# 1984 - 1990 Corvette: Service Bulletin: Underhood Lamps Inoperative or Staying On

**Bulletin Number:** 90-248-8B

**Date:** 05-07-1990

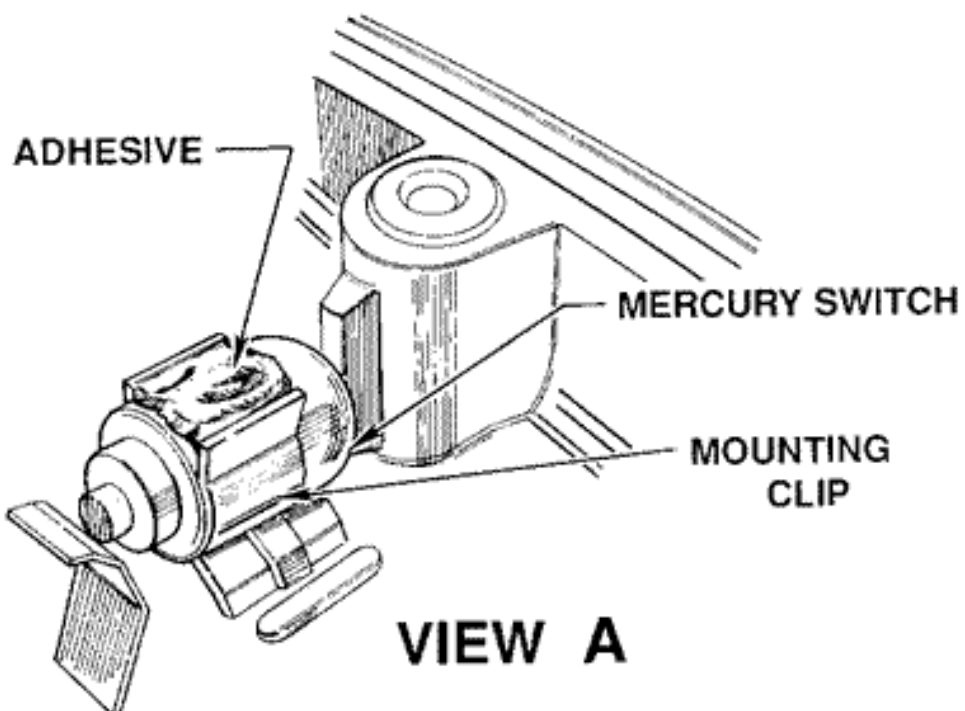
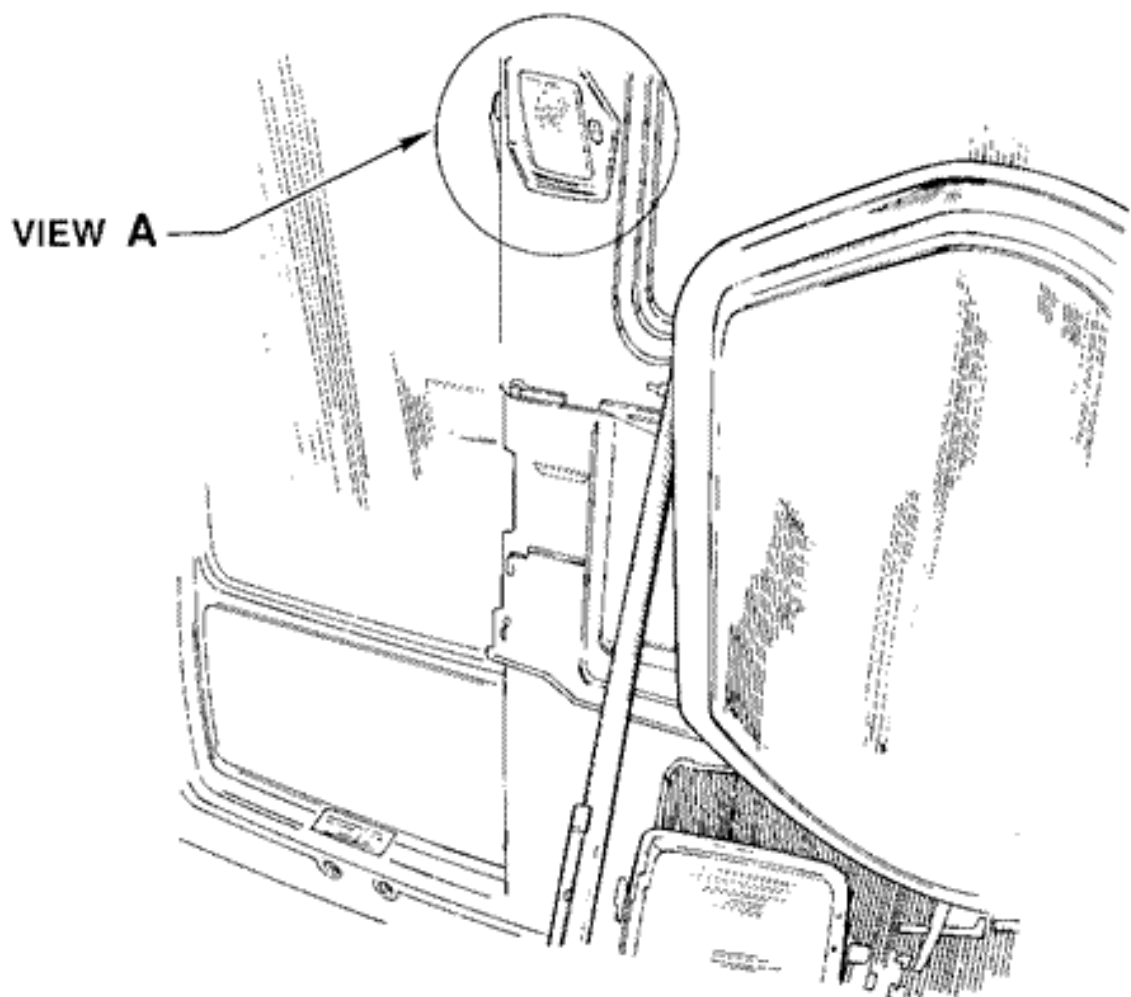
1. Mercury switch disengaged from retaining clip in lamp housing.
2. Mercury switch partially disengaged, and shorting across terminals.
3. Mercury switch has either short or open circuit internally.

**IMPORTANT: If lamps are still on with the hood almost closed, the mercury switch may be shorted. Replace the switch with P/N 16503204.**

5. Raise the hood to full open, and apply a bead of 3M #08670 T3 Silicone, Permatex #26B High Temp R.T.V. (or equivalent) across the switch and clip ends for retention as shown in the illustration.
